CITY OF BEAVERTON
DESIGN EXCEPTION REQUEST

Curb Return Radii Design Exception Request – Additional Information

Horizontal Alignment Design Exception Request – Additional Information

SW DENNEY ROAD
 SW 105TH AVE TO SW SCHOLLS FERRY ROAD
 WASHINGTON COUNTY

SHEET TITLE
2A

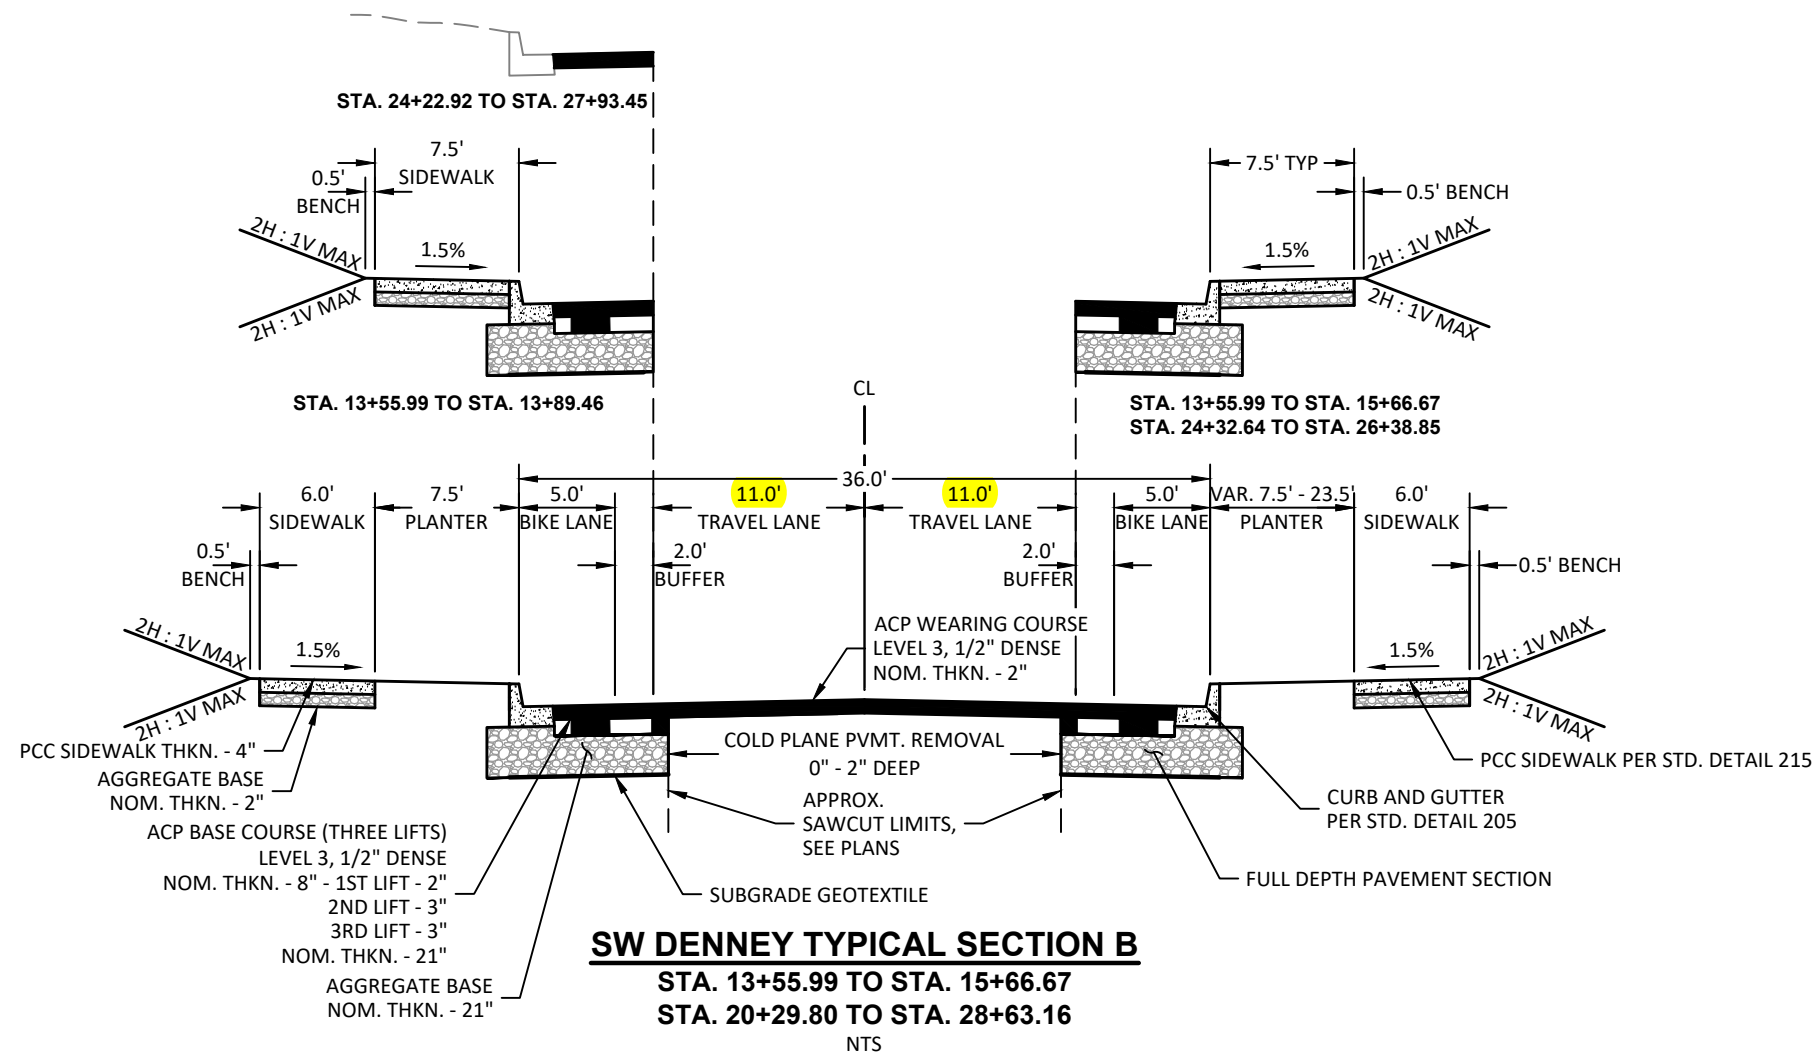
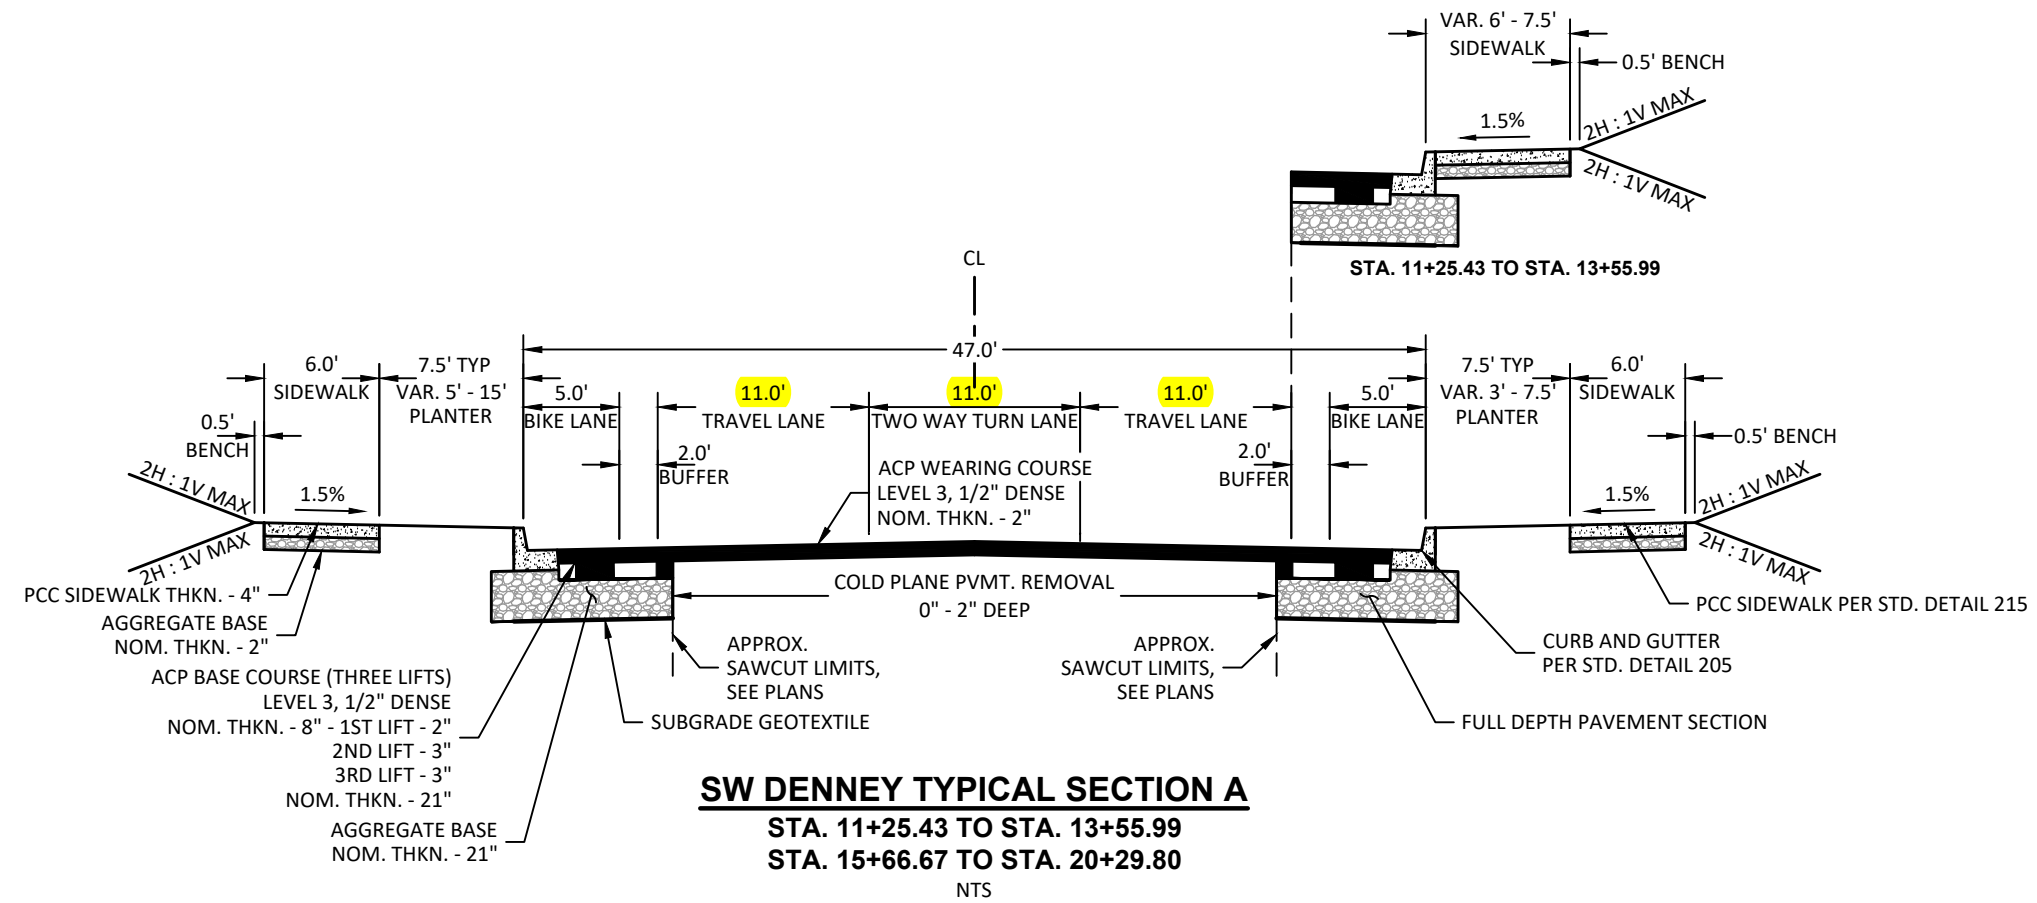
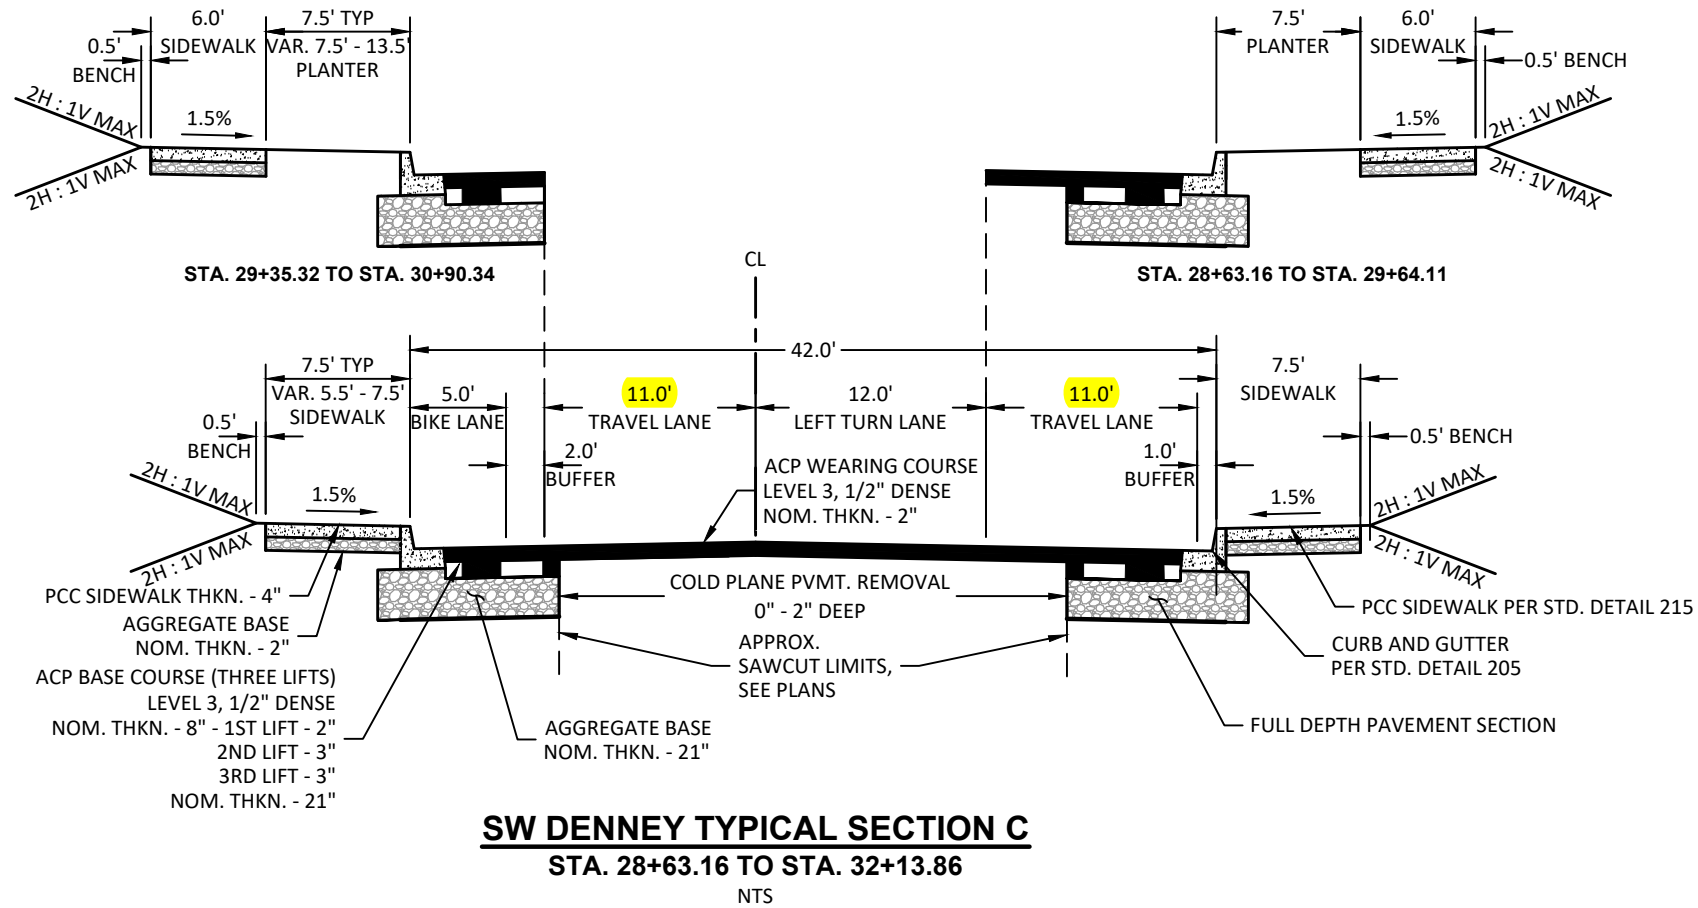
Reasons for Not Attaining Standard: The primary reasons for not meeting the 12' lane width requirements along this corridor is the limited and inconsistent existing right of way, as well as the roadway proximity to existing, significant trees. Providing increased protection to cyclists along the corridor was of high importance – the design team concluded that a reduced lane width in combination with the addition of a 2' bike lane buffer meets the needs of the corridor more effectively than the standard roadway section presented in Standard Detail 200-2. Reduced lane widths allow for all components of the proposed section in areas of limited right of way while limiting the impacts to existing trees and private improvements.

Mitigations for Exception Included in Design: Traffic calming measures including striped cross walks, RRFBs, and reduced centerline radii will all reduce speeds along the corridor and support the use of reduced lane widths. 2' buffers between the bike lane and travel lane are included to provide additional separation and protection to cyclists.

SHEET NO.
 39 OF 84
 SHEET TITLE
3

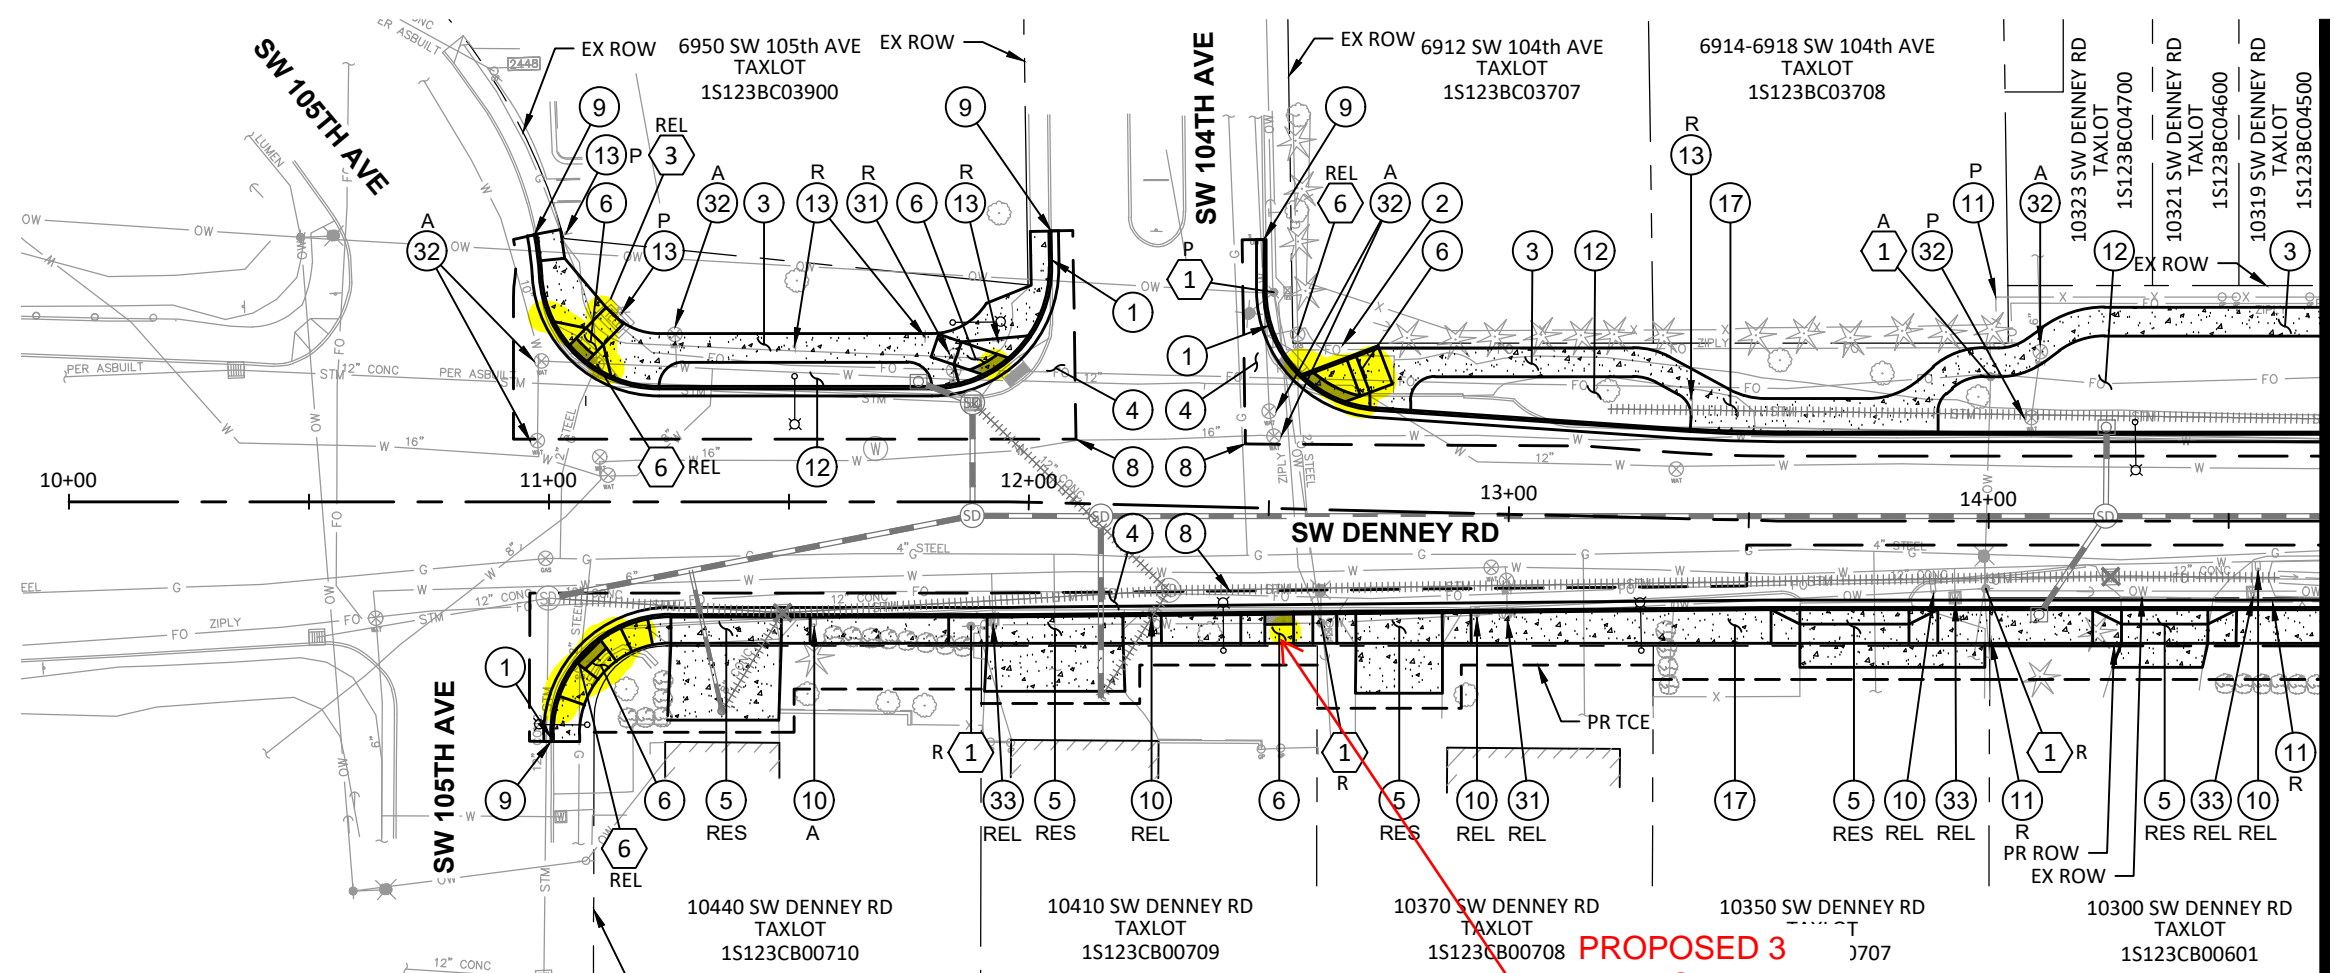
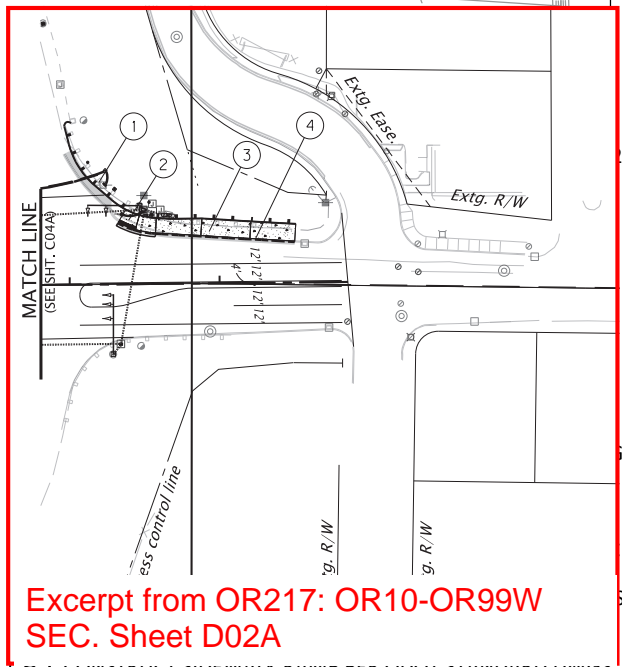
PROPOSED DESIGN MODIFICATIONS:

- 6' CURB TIGHT SIDEWALK - 11+25.43 RT. TO 13+55.99 RT. TO AVOID IMPACTS TO ADJACENT PRIVATE IMPROVEMENTS.
- 6' CURB TIGHT SIDEWALK - 13+55.99 LT. TO 13+89.46 LT. TO AVOID TREE IMPACTS.

- 11' TRAVEL LANES - 11+25.43 TO 32+13.86 TO ACCOMMODATE THE NEEDED MULTI-MODAL IMPROVEMENTS WHILE MINIMIZING IMPACT TO TREES AND ADJACENT PROPERTIES.
- NE CORNER OF SE DENNEY RD AND SE 105TH AVE - SINGLE ADA RAMP TO ALIGN WITH ADJACENT CORNERS.

- SE CORNER OF SE DENNEY RD AND SE 105TH AVE - SINGLE ADA RAMP TO ALIGN WITH RECEIVING RAMP AND AVOID PRIVATE PROPERTY IMPACTS.
- NW CORNER OF SE DENNEY RD AND SE 104TH AVE - SINGLE DIRECTIONAL ADA RAMP TO ALIGN WITH RECEIVING RAMP ON EAST SIDE OF INTERSECTION. DRIVEWAYS ON THE SOUTH SIDE PRECLUDE A RAMP AT THIS INTERSECTION.

- NE CORNER OF SE DENNEY RD AND SE 104TH AVE - SINGLE ADA RAMP TO SERVE BOTH CROSSINGS DUE TO LIMITED RIGHT OF WAY AND PLACEMENT OF RAMP ON THE SOUTH SIDE DUE TO DRIVEWAY LOCATIONS.

SHEET NO.
 41 OF 84
 SHEET TITLE
4

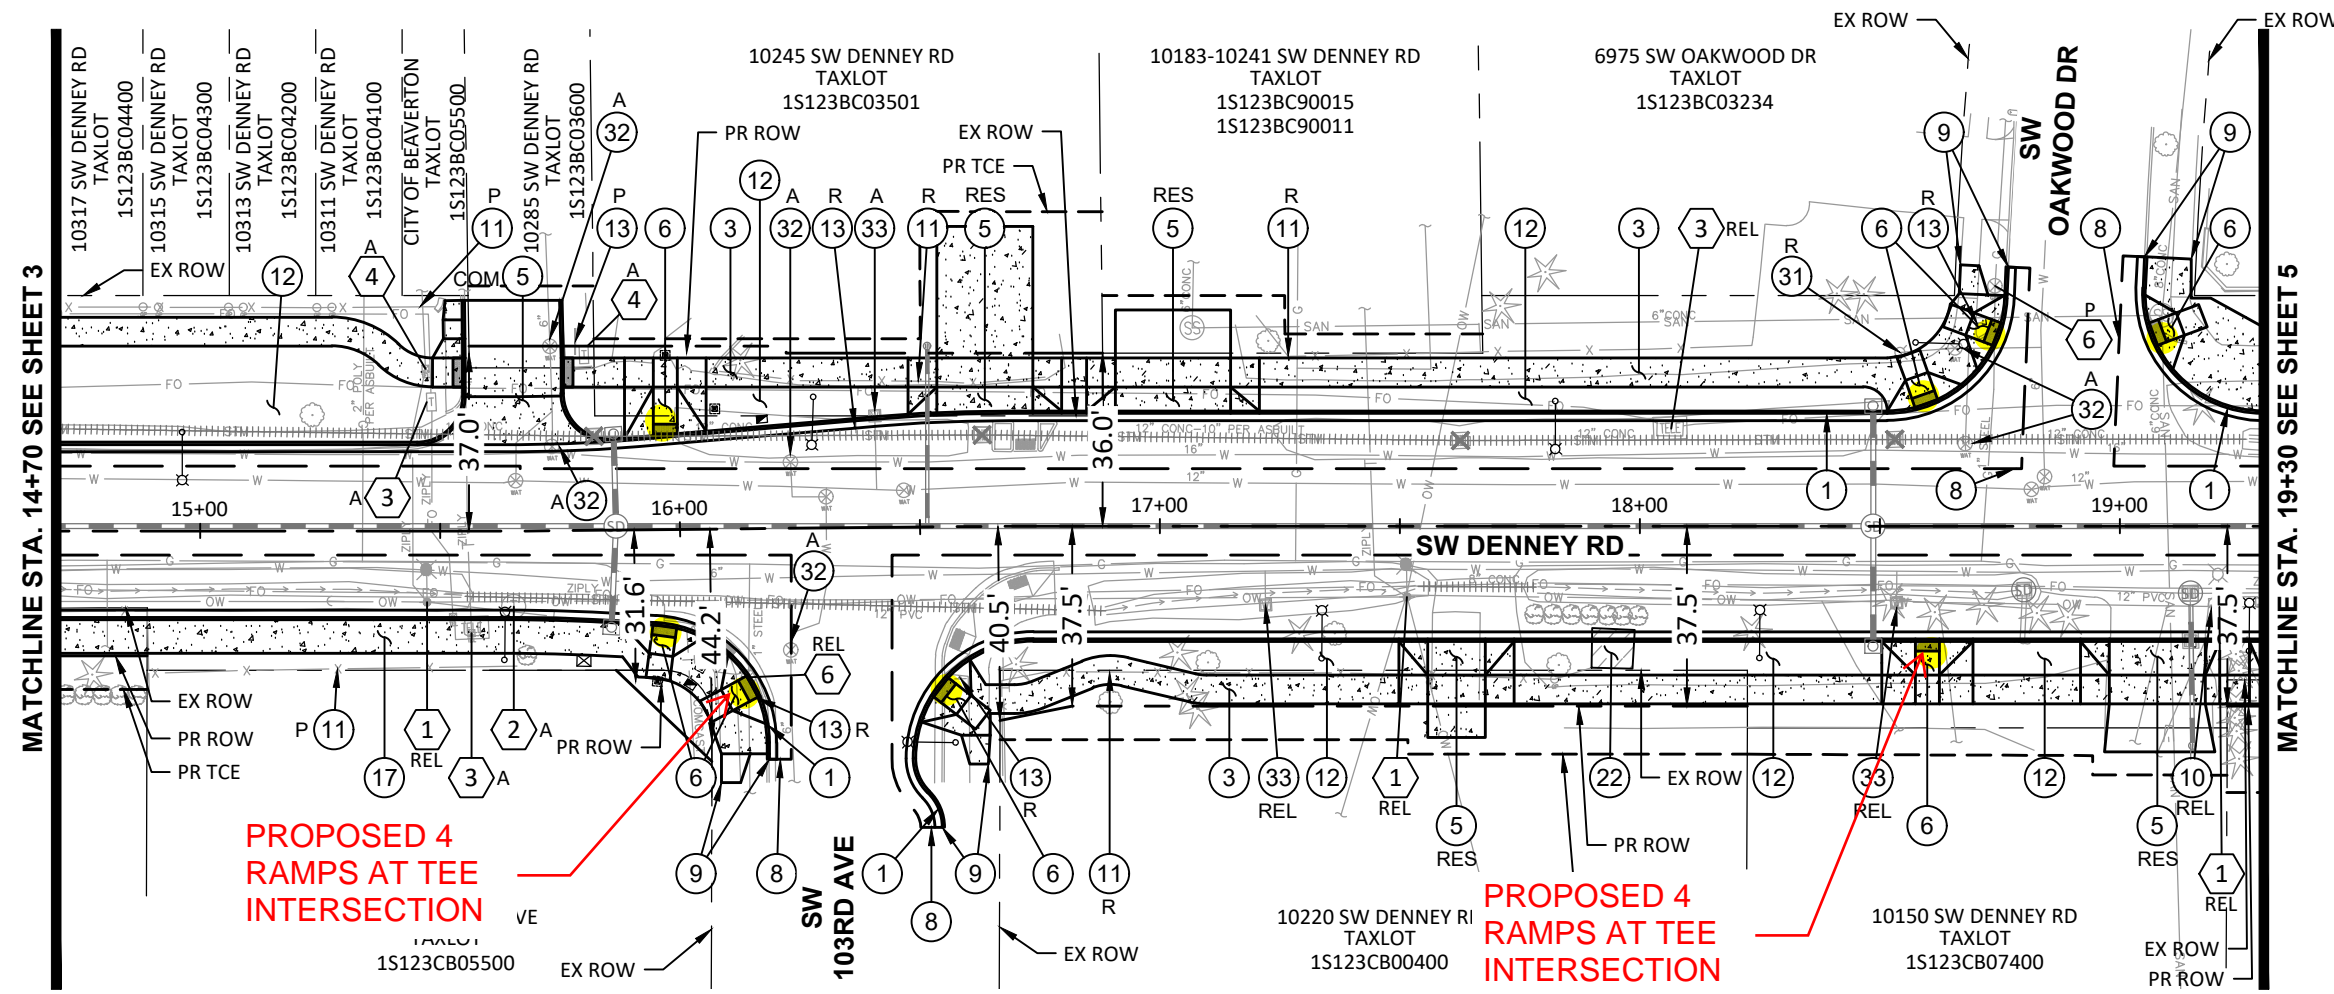
PROPOSED DESIGN MODIFICATIONS:

WEST SIDE OF SW DENNEY RD AND SW 103RD AVE - NO PEDESTRIAN RAMP ON NORTH SIDE DUE TO CONFLICT WITH DRIVEWAY AND DESIRE TO ENCOURAGE PEDESTRIANS TO USE THE RRFB PEDESTRIAN CROSSING ON THE WEST LEG.

EAST SIDE OF SW DENNEY RD AND SW OAKWOOD DR - NO PEDESTRIAN RAMPS ON EAST SIDE OF INTERSECTION DUE TO CONFLICT WITH DRIVEWAY.
